Plan Commission

Agenda

Monday, April 25, 2016

Item 4: Review and Recommendation on the Site Plan Application for De Pere Café, located at 1104 Honey Court (ED-1469). Applicant: Alliance Construction & Design

HDPE /PVC SEWER & WATERMAIN & FORCEMAIN BEDDING & TRENCH SECTION

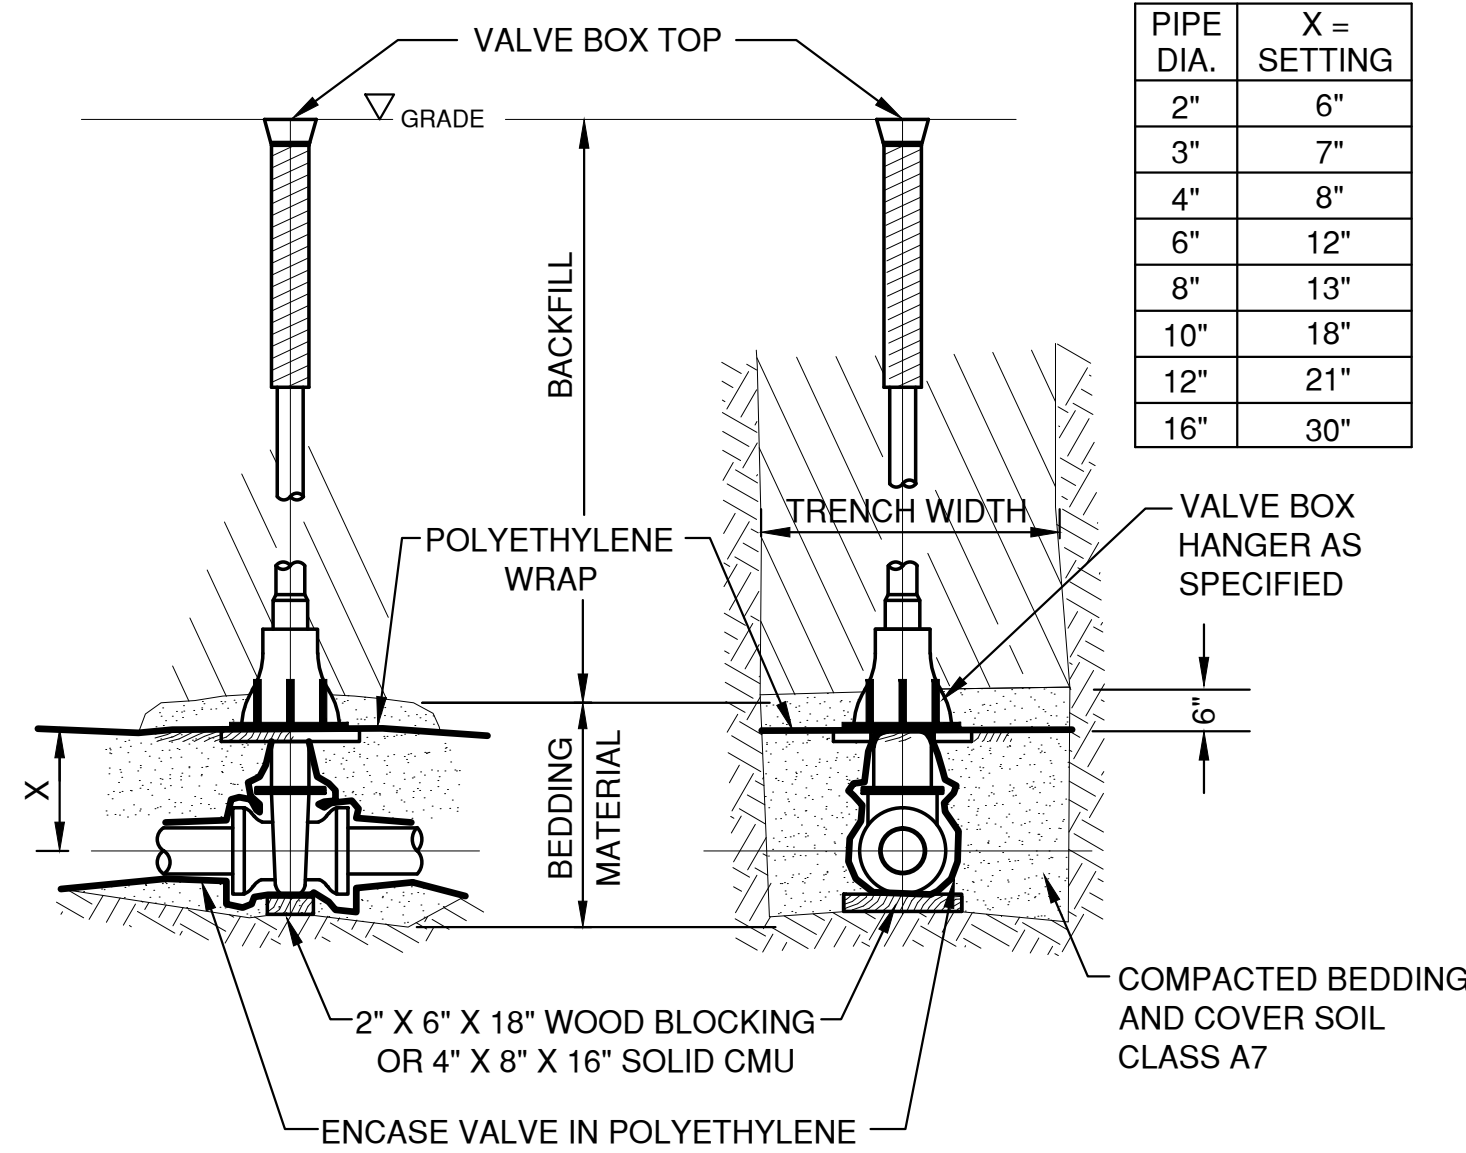
5. Curb cut permits are required for new driveways. Remove the curb removal details shown on sheet 4 of the plan. New curb will be required along the alley that complies with the City of De Pere Construction Specifications. Show the width of the driveway flares on the plan.
